PROJECT: Showboat Mixed-Used Development

CITY OF LAS VEGAS INTER-OFFICE MEMORANDUM		DATE: April 1, 2019
TO: Land Development Services Department of Building & Safety		FROM: Albert Sung, P.E. Flood Control Project Engineer Department of Public Works
SUBJECT:	Drainage Study for: Showboat Mixed-Used Development	COPIES TO: Lochsa Engineering
Cross Streets:	NWC of Fremont Street & Oakey Boulevard	Bentar Development
File Number:	F:\Depot\DSMemos\DS5085B.doc	Bart Anderson, P.E., DevCo
Parcel Number:	162-01-201-006, 162-01-201-007, 162-01-201-008	CCRFCD
Zoning Action:	SDR-74657; SUP-74656 & SUP-74781	CCPW
FEMA Flood Zone	YES NO X	NDOT
Proposed Storm Drain	YES NO X

Addendum to Technical Drainage Study for Showboat Mixed-Used Development

COMMENT LETTER

GRADING PLANS
SHEET 8

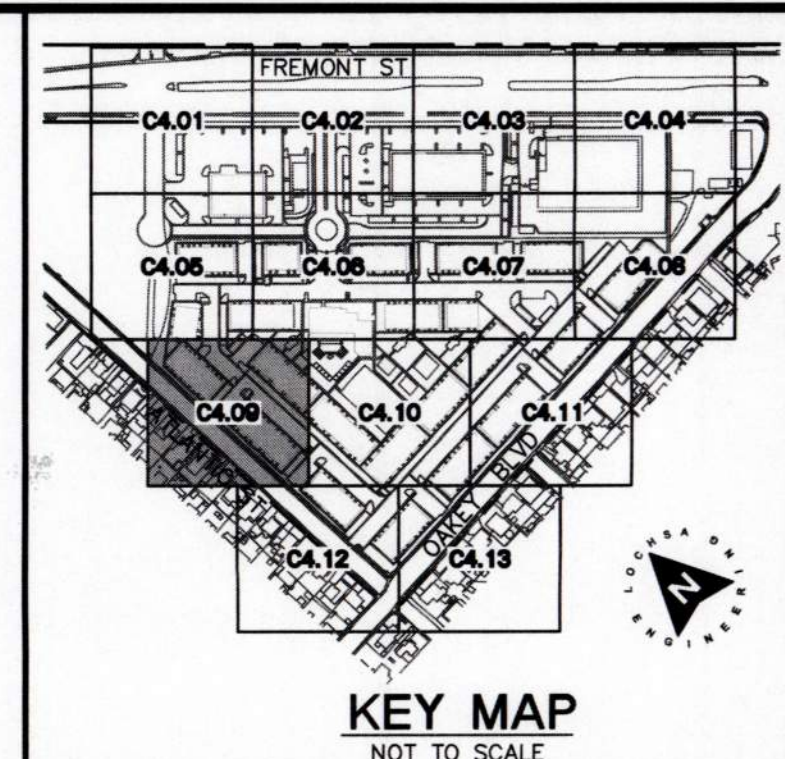
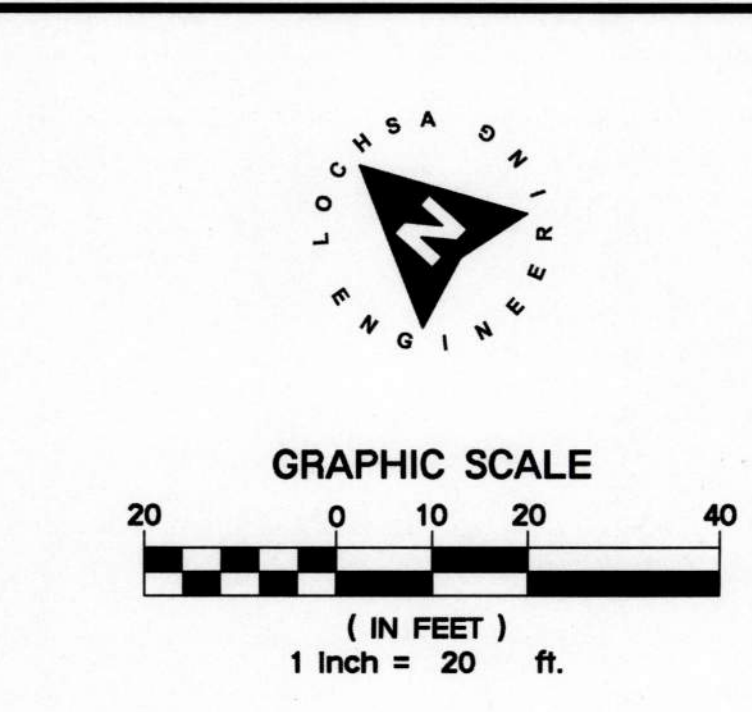
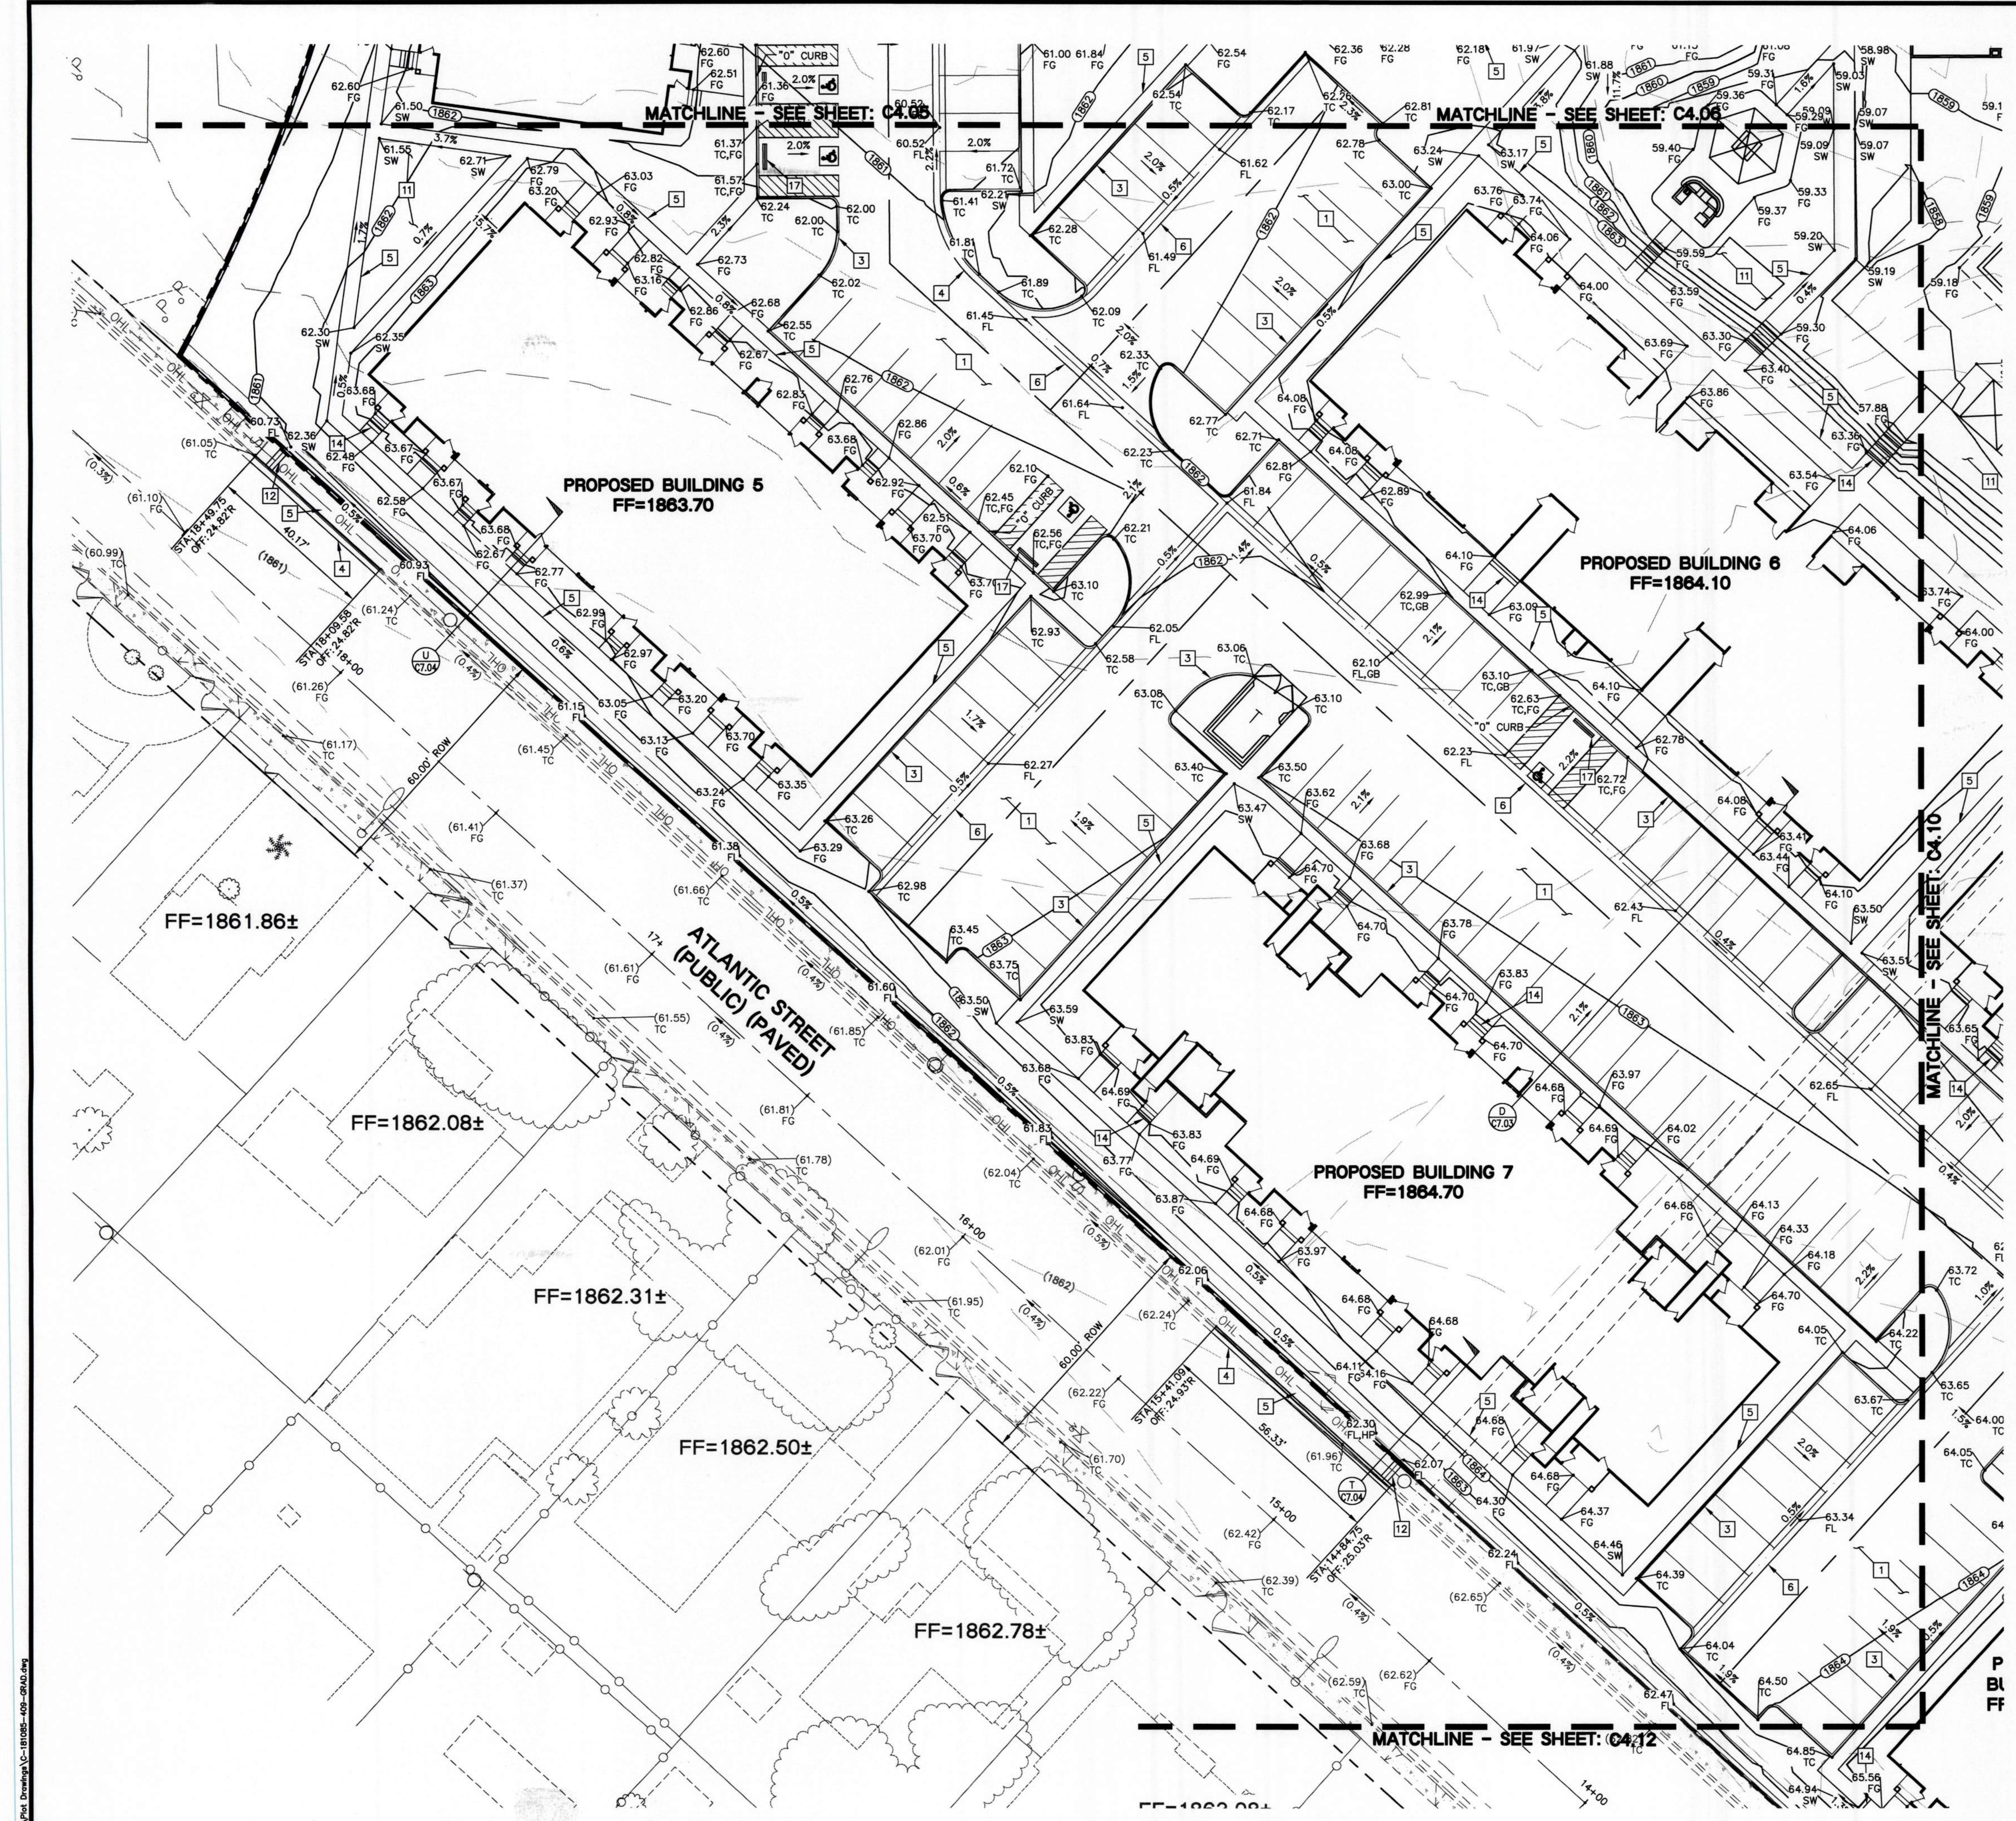
11. **Sheet C4.08:** Provide a cross section at **Building 17** which shall include the building and the adjacent *Oakey Boulevard*. Note that the 100-year flow in *Oakey Boulevard* is erosive at 7.39 ft/s, the section detail shall show erosion protection measures in the landscape portion behind the sidewalk.

Response 11: We have provided a Cross Section Detail 'V' (Sheet C7.04) that extends from our proposed Building 17 to Oakey Blvd. Please note that there is an existing wall that runs along Oakey Blvd. that prevents flows from getting on our site. Therefore, even though the flows are erosive (7.39 ft/s), they do not impact our proposed Building 17. However, since the existing wall jogs into our site near Building 17, we have provided a hydraulic calculation and rip rap calculation for that landscape area to contain the erosive velocity within that landscape area. See hydraulic calculation, riprap calculation and revised Plans that reflect the landscape portion.
